UNITED STATES PATENT AND TRADEMARK OFFICE

APPLICATION NO.	FILING DATE	FIRST NAMED INVENTOR	ATTORNEY DOCKET NO.	CONFIRMATION NO.
10/774,799	02/09/2004	Perry Scott Lorenz	1361015-2059/PO5790	9070
38845 7590 04/18/2011 FLH/National Semiconductor Corporation c/o Frommer Lawrence & Haug LLP 745 Fifth Ave. NEW YORK, NY 10151			EXAMINER ALMO, KHAREEM E	
			ART UNIT 2816	PAPER NUMBER
			MAIL DATE 04/18/2011	DELIVERY MODE PAPER

Office Action Summary

DETAILED ACTION

Fig. 5

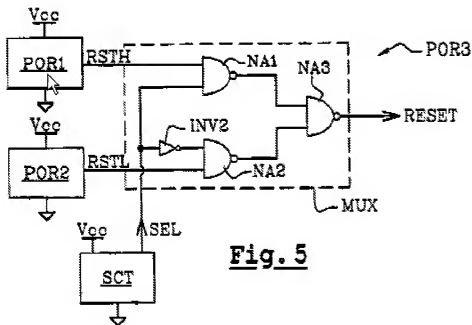
Figure 5 of La Rosa (US 6897689) discloses a POR circuit to generate a reset signal. It would have obvious at the time the invention was made to a person having ordinary skill in the art to use the POR reset circuit of Rosa in the Voltage detecting

circuit of Matsumura for the purpose of incorporating a POR circuit into an integrated circuit that can receive different supply voltages.

With respect to claim 2, the combination above produces the circuit of Claim 1, wherein the power-on-reset (Fig 5 of La Rosa) signal is the gate control signal.

With respect to claim 3, the combination above discloses the circuit of Claim 1, further comprising: a timer circuit (SCT) that is configured to provide a mute signal in response to the power-on-reset signal (POR3), wherein the mute signal is the gate control signal.
